Work Order ID 114564

Item Name: Replacement Skidtube(Fits LH or RH)

| DRAWING NO. D2650 | TITLE 206/407 SKIDTUBE ASSEMBLIES | REV. F | DART AEROSPACE LTD ENGINEERING ORDER | | D.E.O. NO. D2650-F-1 | SHEET NO. SHEET 1 OF 1 | SCALE NTS |

CHANGE C'BORED WELDED CROSSBOLT SPACERS TO SWAGED SPACERS

DETAIL B

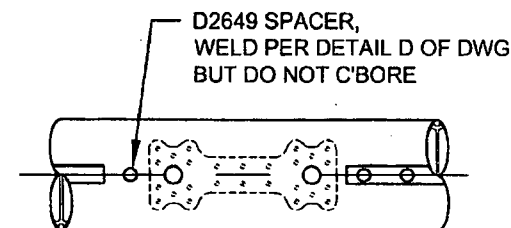
C'BORED HOLES ARE **NOW SWAGED** PER DETAIL G BELOW. FOR THE Ø0.375 HOLE THAT IS NOT C'BORED, WELD PER DETAIL D OF DWG (SEE AMENDED DETAIL B FOR REFERENCE).

AMENDMENT TO DETAIL B
NOT TO SCALE

DETAIL G

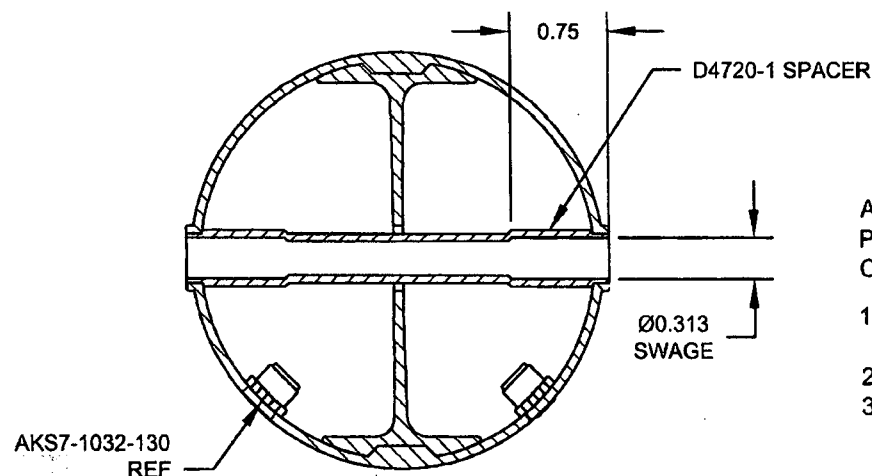
ADD DETAIL G BELOW, WHICH IS THE SAME SECTION VIEW AS DETAIL D OF DWG.
